**ON-SITE SEWAGE DISPOSAL SYSTEM
HOWARD COUNTY HEALTH DEPARTMENT
BUREAU OF ENVIRONMENTAL HEALTH**

SUBDIVISION: Chapel Woods III LOT NUMBER: 31

ADDRESS: 11770 Chapel Estates Drive PROPERTY OWNER: Williamsburg Group, LLC

HOWARD Co. HEALTH DEPT.	DATE 9-5-00	JOB NO. 00-090
3525-H ELLICOTT MILLS DRIVE	RE: Chapel Woods III	
ELLICOTT CITY, MARYLAND	Lot 31	
ATTENTION: Amy McMillen	G.P. 01-15

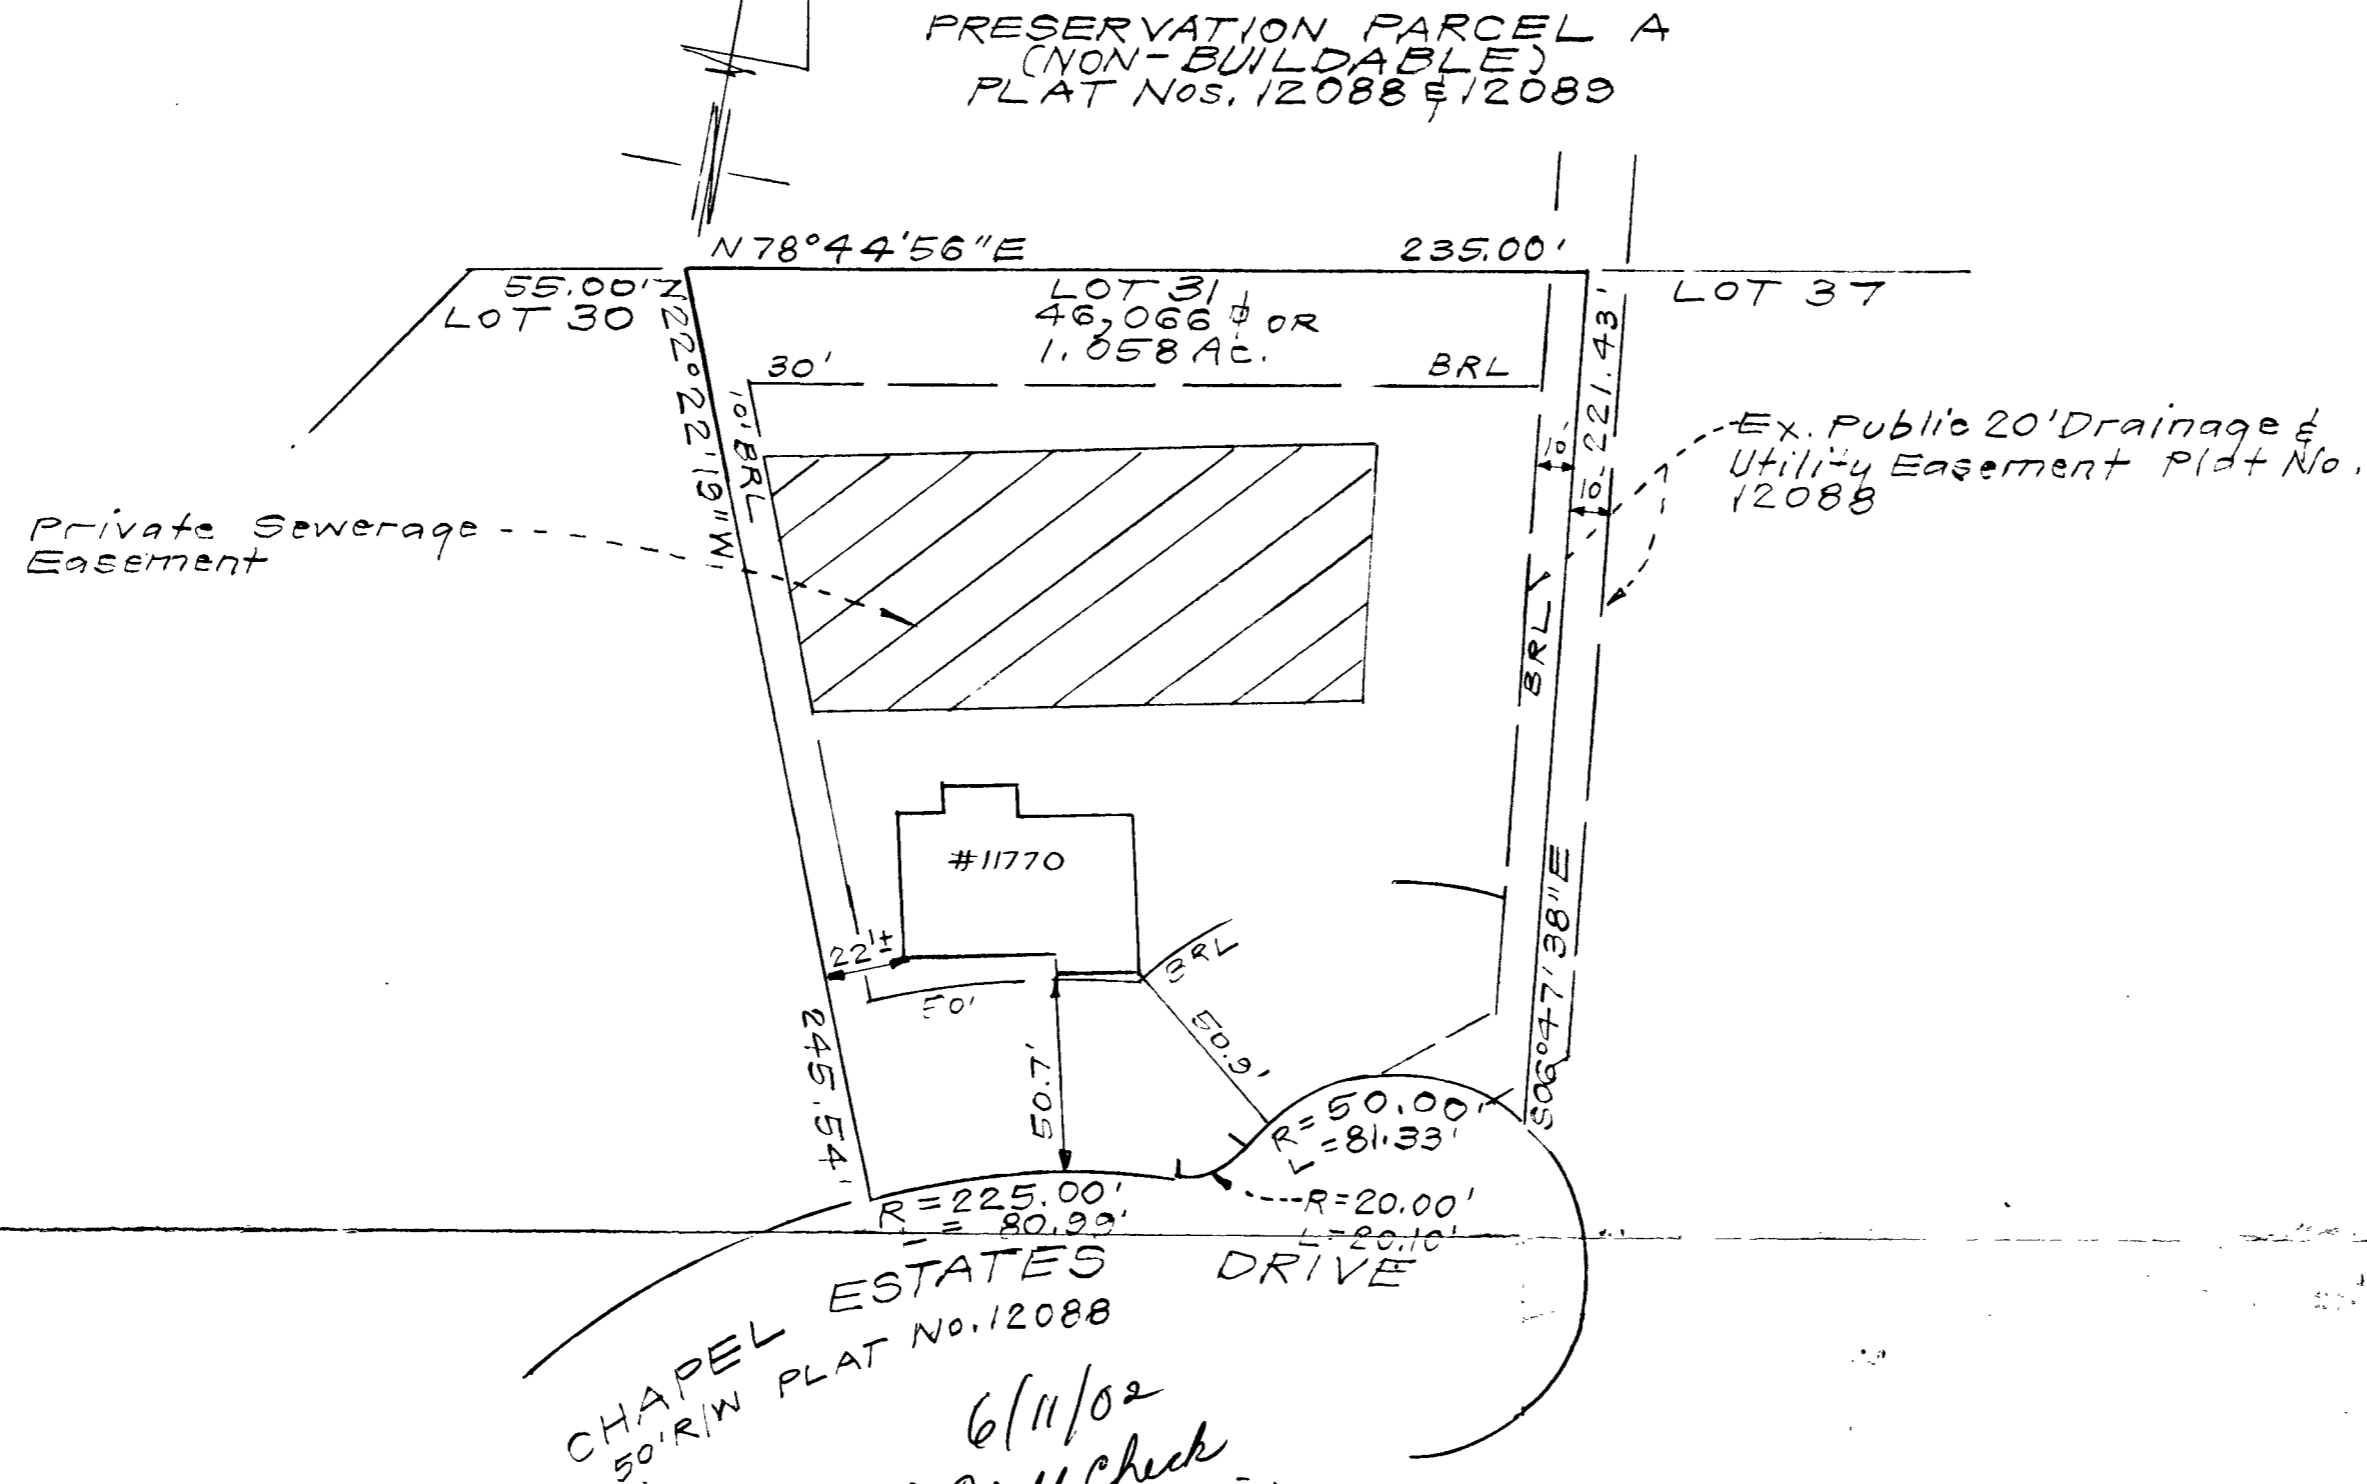
PRE-CONSTRUCTION 10/3/02 hot staked, contour accurate. Layout per B.P. (SO)

INSTALLATION 10/4/02 OK to cover all work (SO)

Approved Septic System Plan Howard County Health Department

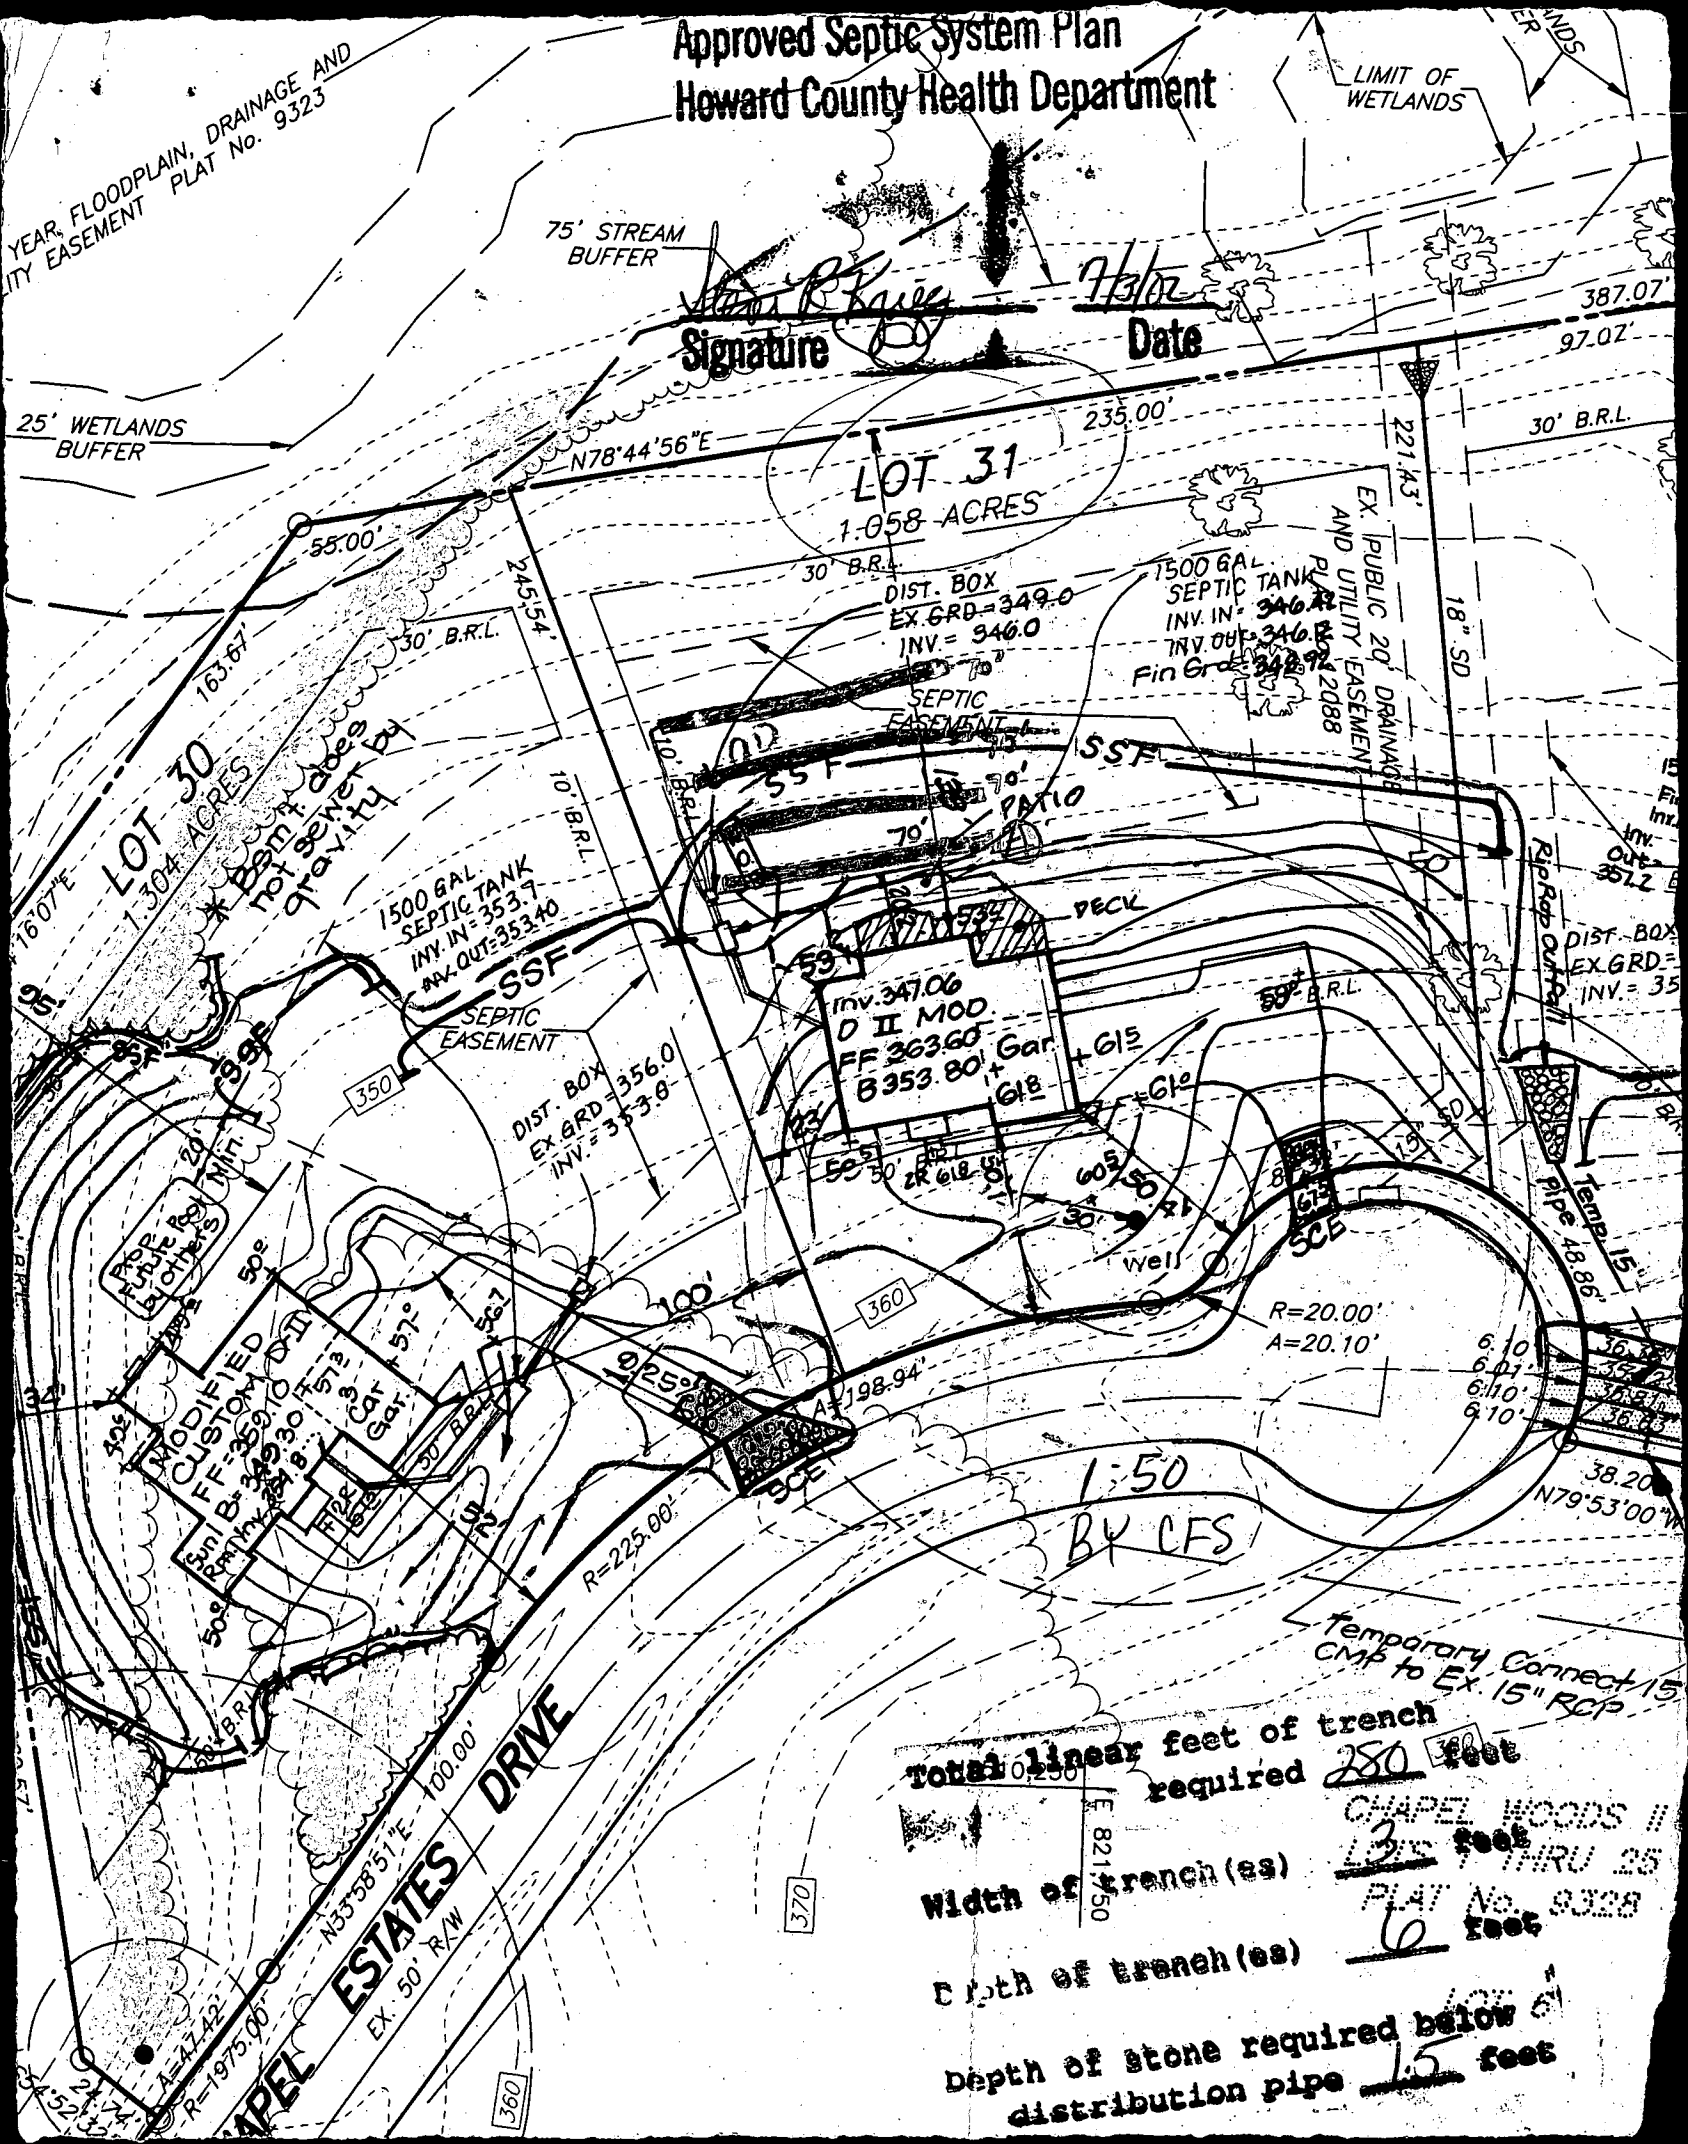
6/11/02
Wall Check
Consistent with
B.P. plan.
BB

EXHIBIT # 3

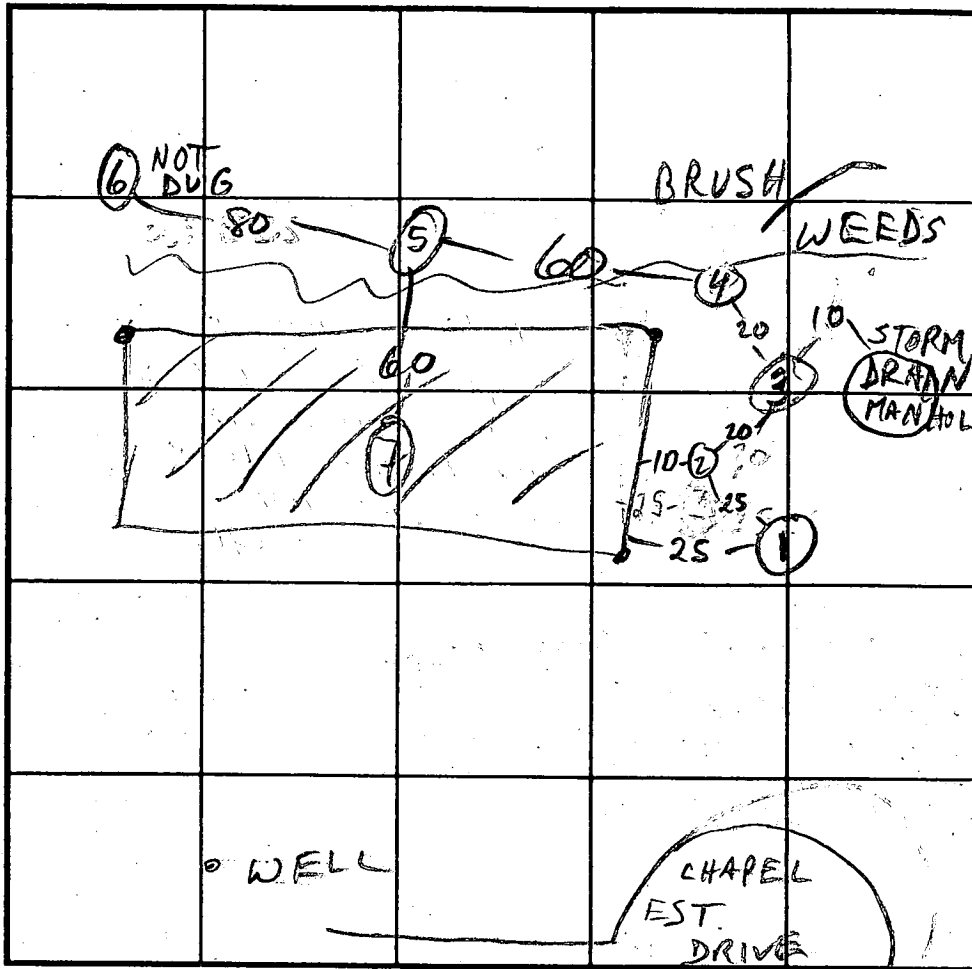
9/6/00 Failed rock hole in this area

RE-PERC TEST NOT acceptable w/pt
PLAN PERC du

Not acceptable w/out
reperc. du

9/11/00 Preview OK
Propose to adjust
SDA as far to the
back & right side of
lot as possible
AW

EXHIBIT # 3 PROPOSED SEPTIC ESMT.

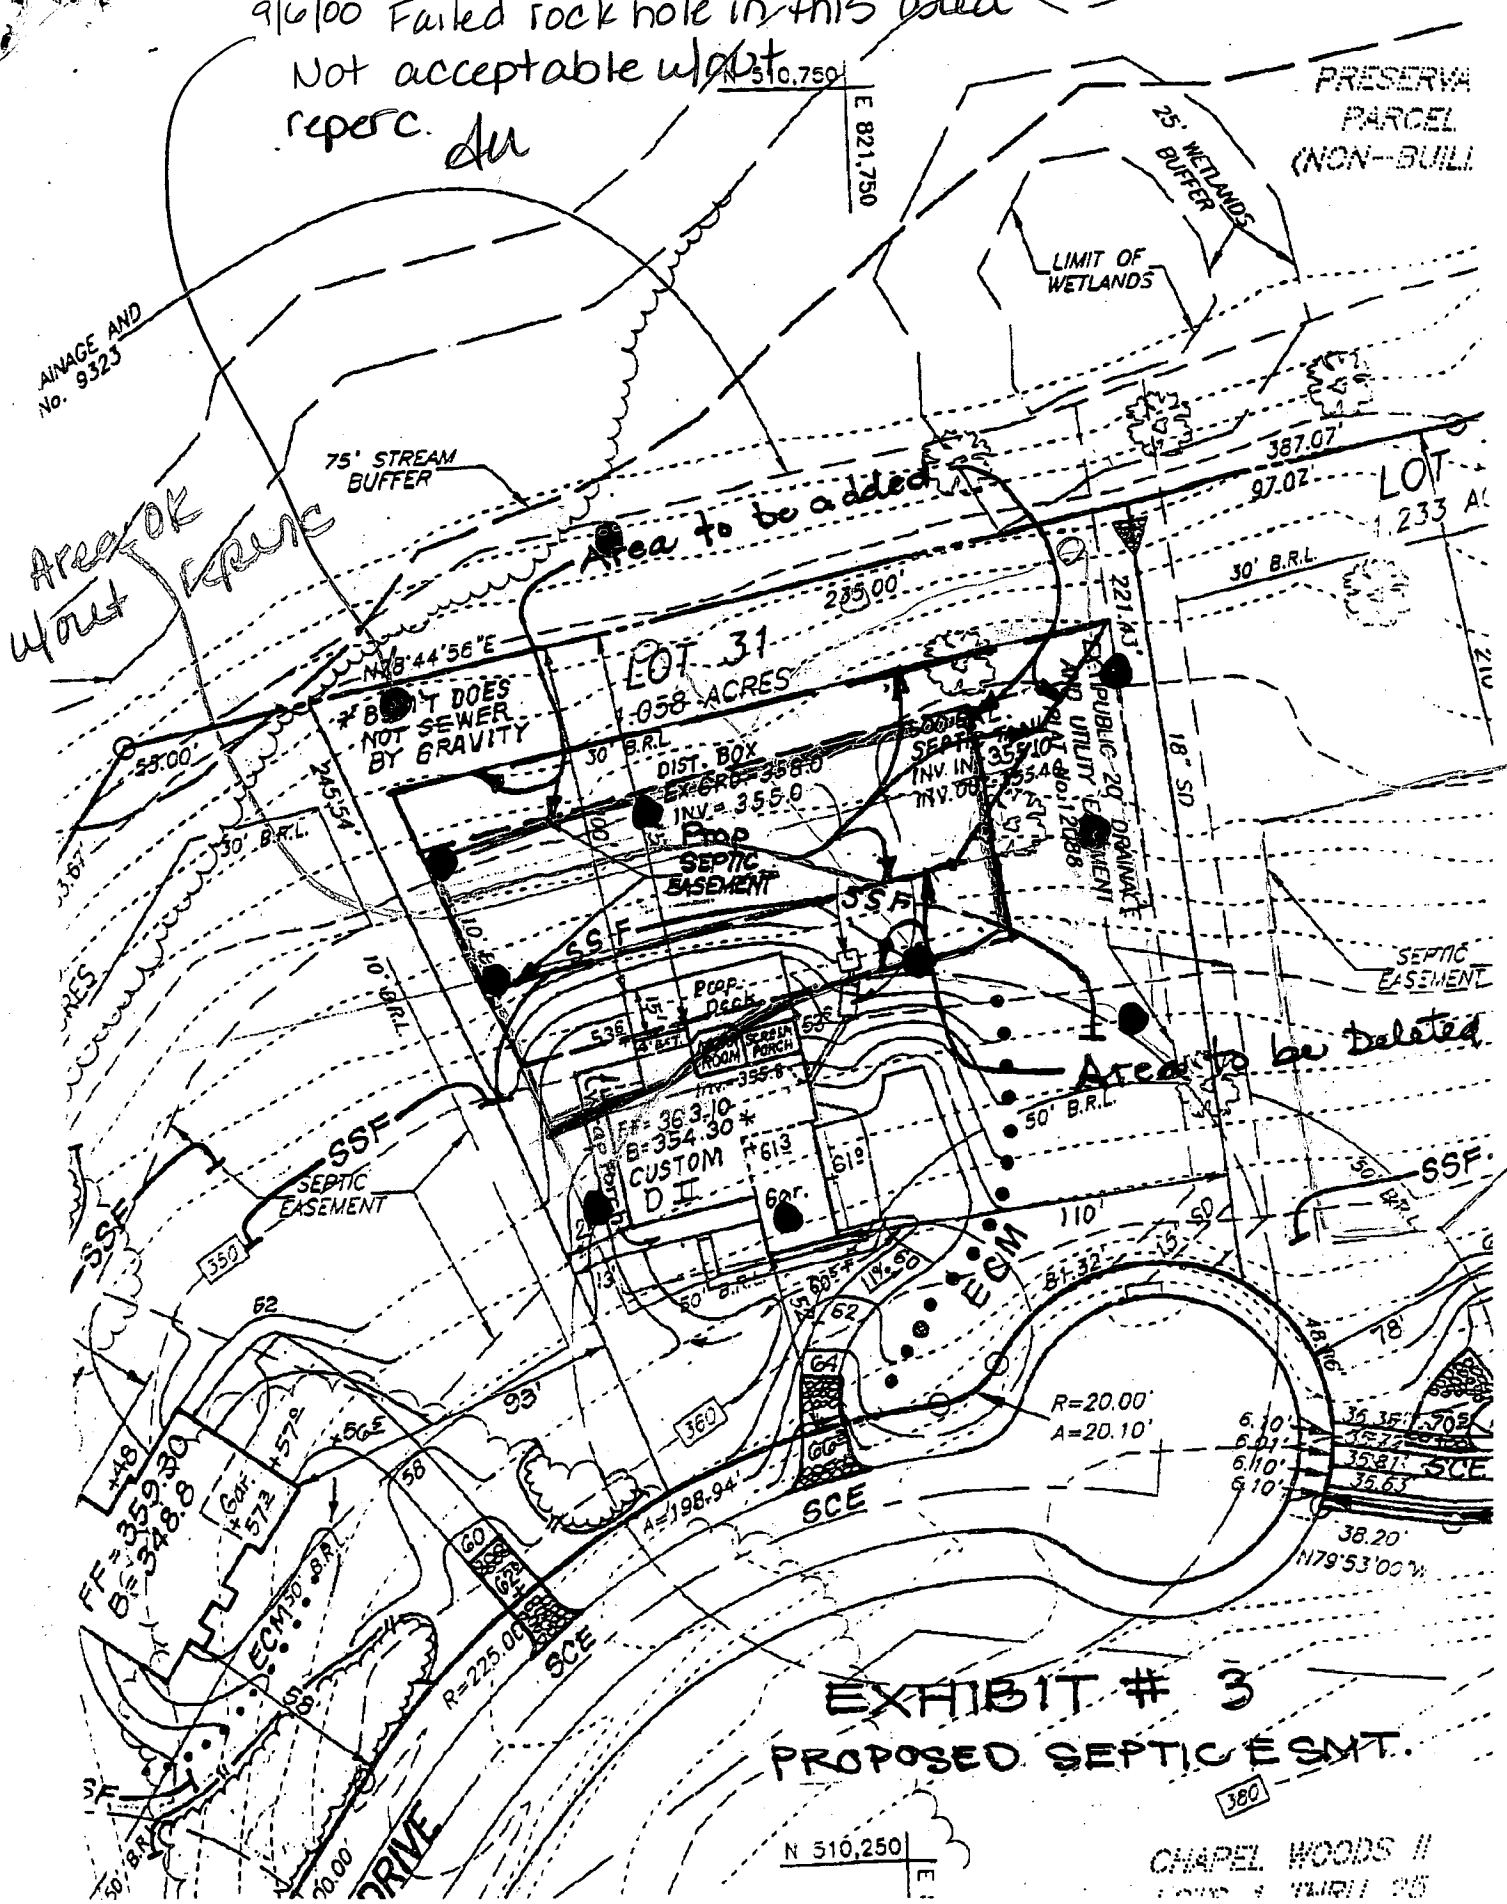
REMARKS: Builder has come up w/ an alternative to the prop
Septic esmt. I sent over on 8-29-00 which was rejected.
Would this revision be acceptable? Please let me
know as soon as possible so prospective homebuyer for
this lot will not be in "limbo" any longer than necessary

9/6/00 Failed rock hole in this area
Not acceptable w/out
reperc. du

Area OK w/out reperc
